New Chiller System Biology II Bldg. 571

Project No: FM100281L/137-14

**Addendum No. 1**

ADDENDUM NUMBER 1

ADM2.1

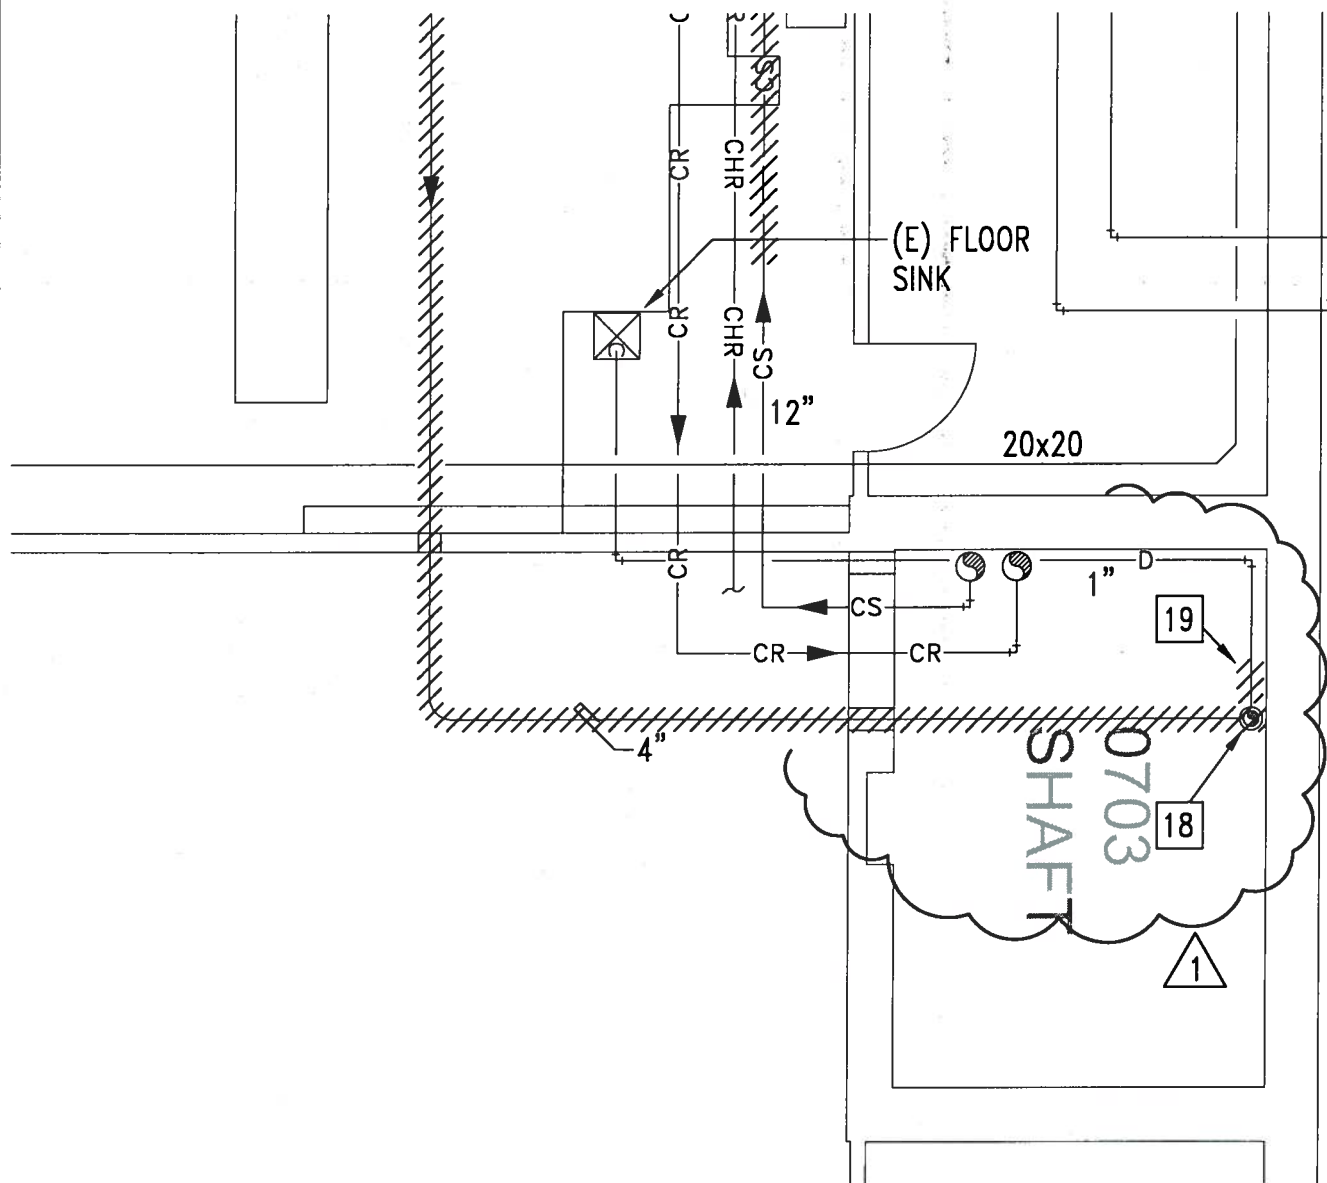
2. Sheet M2.1 “Partial Mechanical Basement Demo Plan”: **Refer** to attached addendum #1 drawings ADM2.1.
3. Sheet M2.2 “Partial Mechanical Basement Floor Plan”: **Refer** to attached addendum #1 drawings ADM2.2a; ADM2.2b; ADM2.2c.
4. Sheet M3.2 “New System Piping Diagrams”: **Refer** to attached addendum #1 drawings ADM3.2a; ADM3.2b; ADM3.2c.
5. Sheet M4.1 “Chiller Details”: **Refer** to attached addendum #1 drawings ADM4.1.
6. Sheet M5.1 “Controls”: **Refer** to attached addendum #1 drawings ADM5.1a; ADM5.1b

- 18 REMOVE (E) ENGINE EXH PIPING, INSULATION, SUPPORTS,  
& REMOVE (E) DISCHARGE PIPE THROUGH ROOF.
- 19 REMOVE (E) TRAP/VALVE.

## ADM4.1

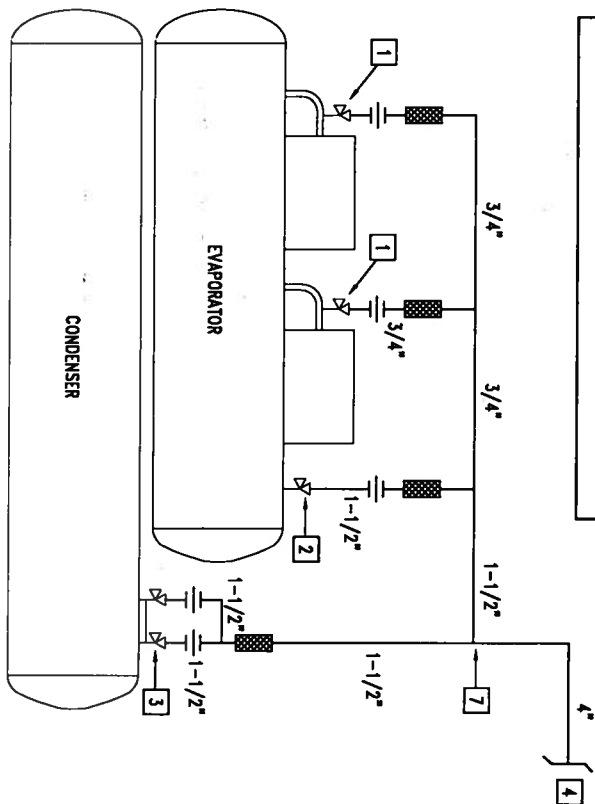
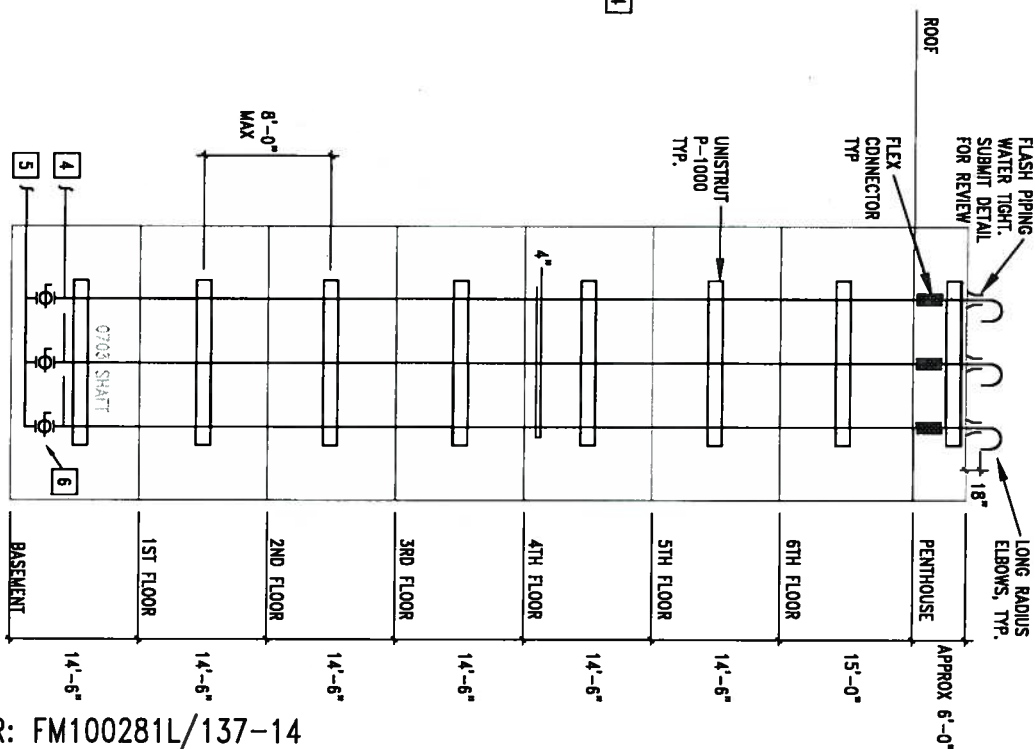
- 1 3/8" SUCTION NOZZLE RELIEF VALVE.
- 2 1" EVAPORATOR RELIEF VALVE.
- 3 1" CONDENSER RELIEF VALVES. ONLY ONE USED AT ANY ONE TIME.
- 4 REFRIGERANT RELIEF PIPING.
- 5 1" DRAIN. CONNECT TO (E) 1" DRAIN.
- 6 3/4" VALVE/PIPE CONNECT TO 1" HEADER.
- 7 BRING 4" PIPE ON AS CLOSE AS POSSIBLE TO CHILLER.

ADM5.1a

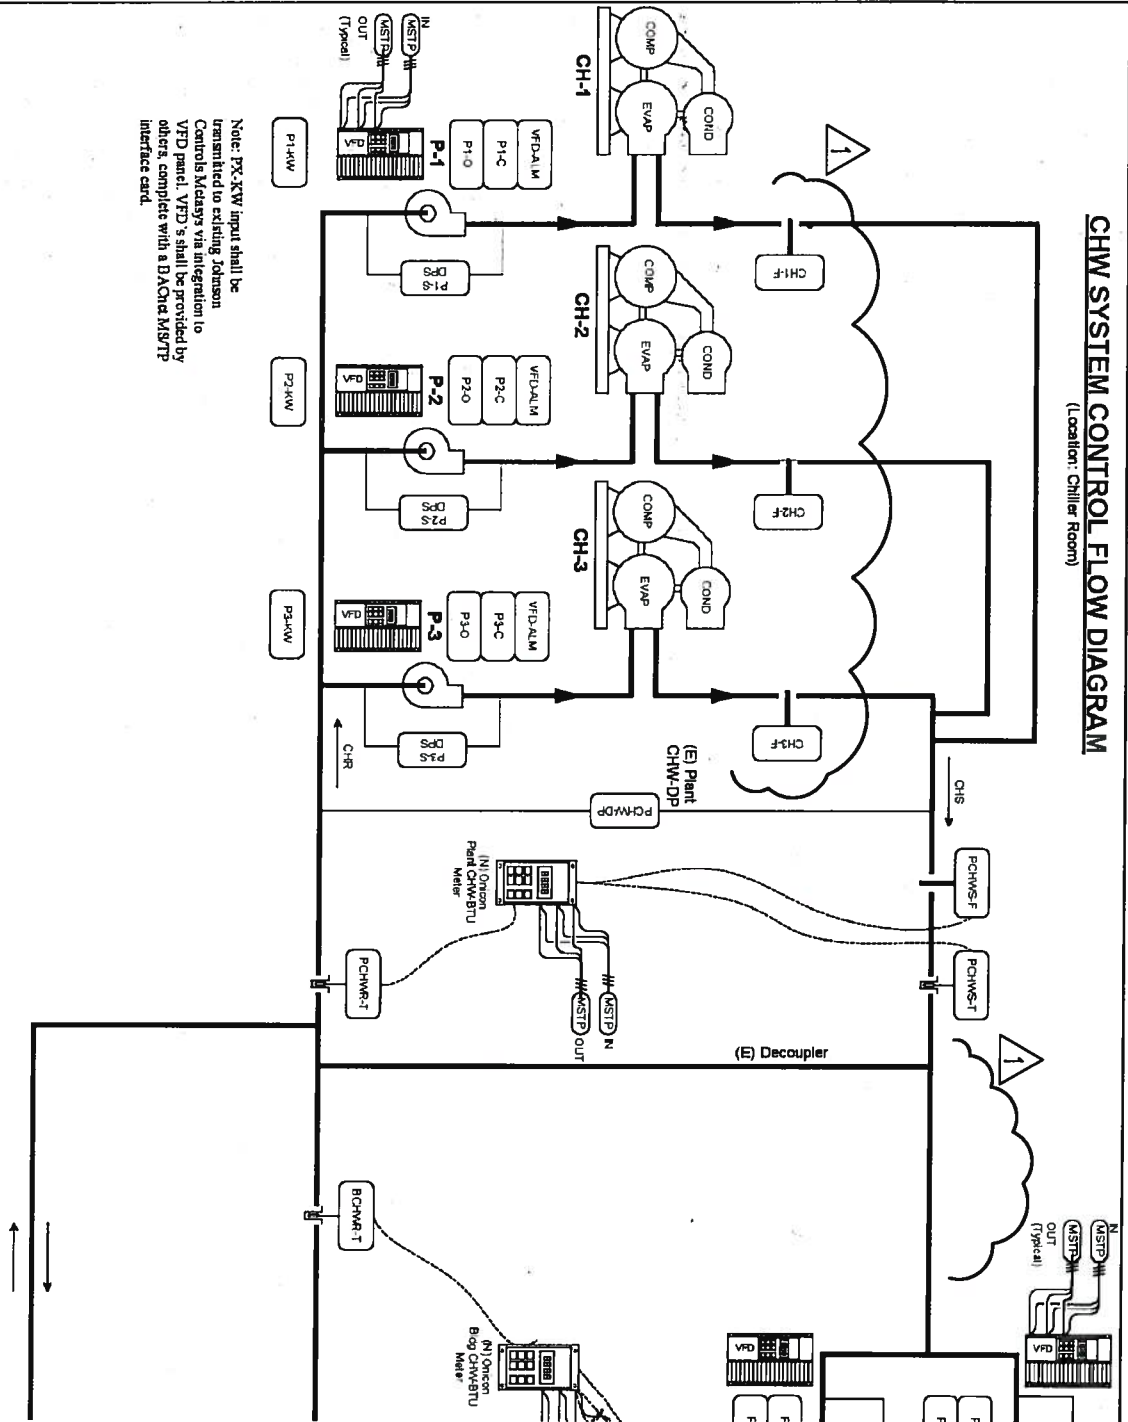
Note: P1-KW input shall be transmitted to existing Johnson Controls Modems via integration to VFD panel. VFD's shall be provided by others, complete with a BACnet MS/TP interface card.

ADM5.1b

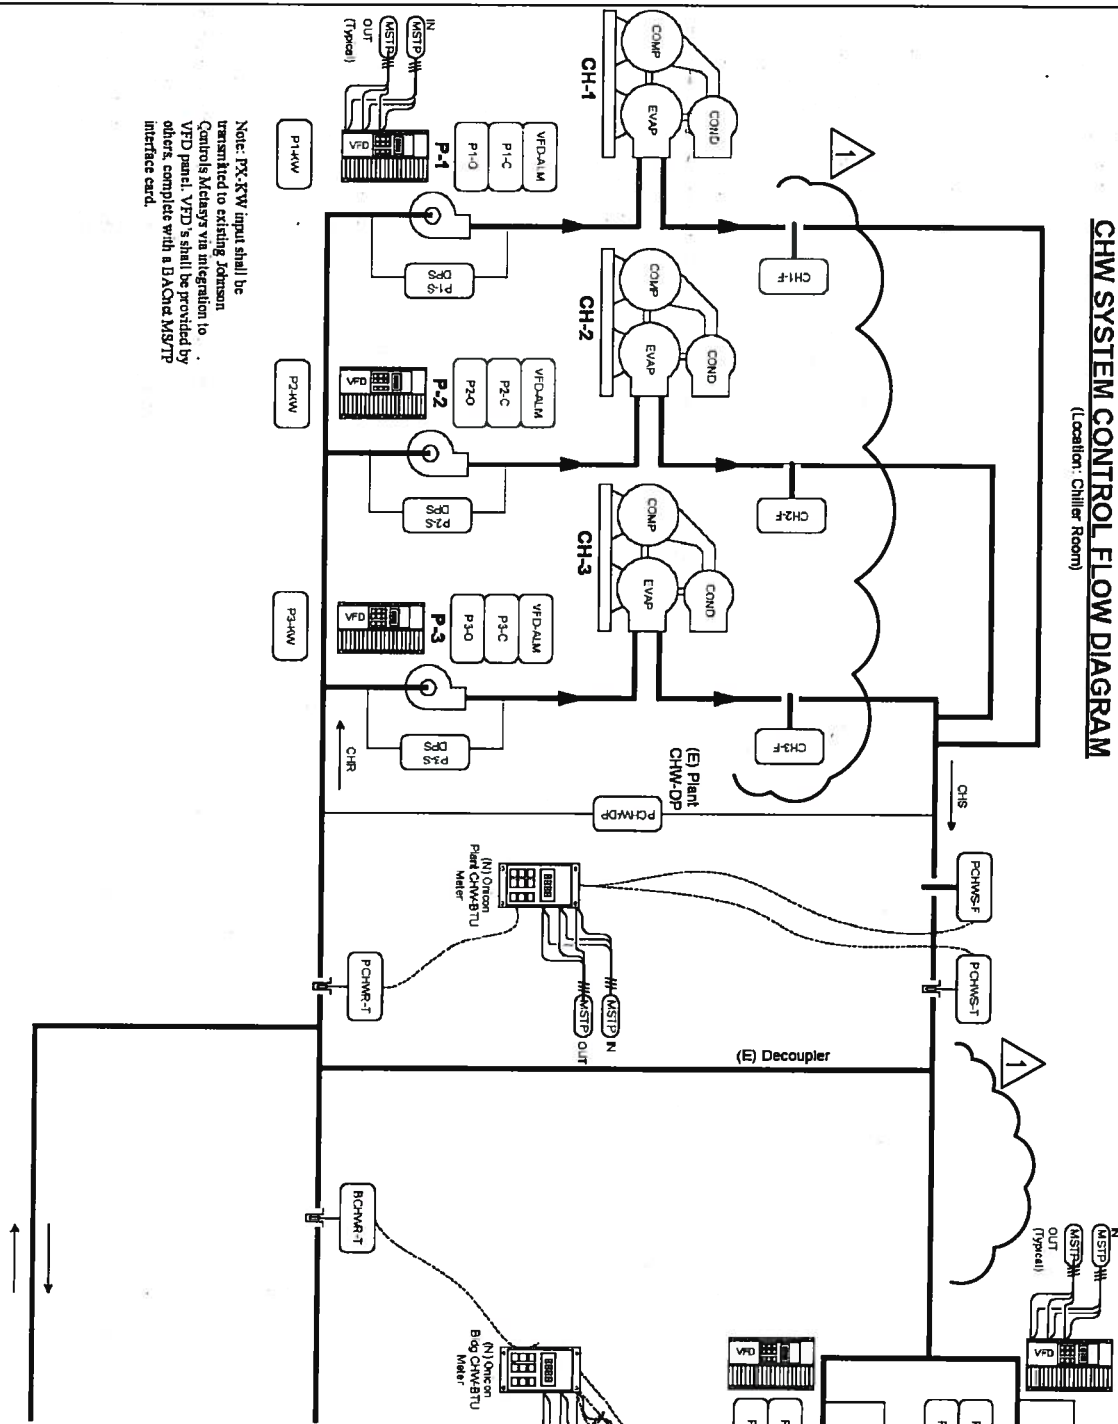
Note: P1, P2, P3 input shall be transmitted to existing Johnson Controls Metasys via integration to VFD panel. VFD's shall be provided by others, complete with a BAOne MS/TP interface card.
